**TECHNICAL BULLETIN**  
**Bell Helicopter** **TEXTRON**

No. 212-04-194

**SUBJECT:** AFCS INDICATORS, REPLACEMENT FOR SPARES

**HELICOPTERS AFFECTED:** Model 212 helicopters serial number 30504 through 31294.

Fig 3

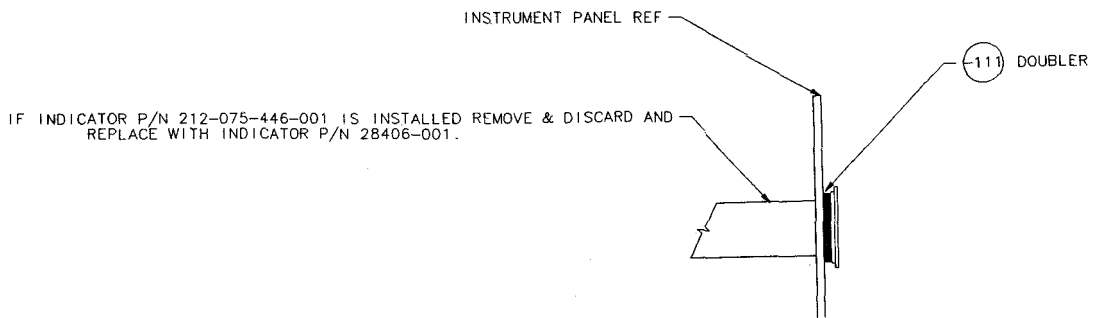
3. Disconnect wires from AFCS indicators, DS44 and DS45.
4. Using fig 2, delete wires as mentioned.
5. Remove and discard AFCS indicators from instrument panel.
6. Install new AFCS indicators in conjunction with doubler –111 as shown in fig 3 and fig. 6.

Fig 6

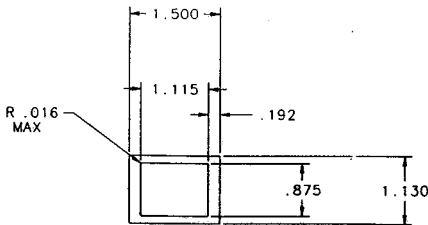
-111 DOUBLER
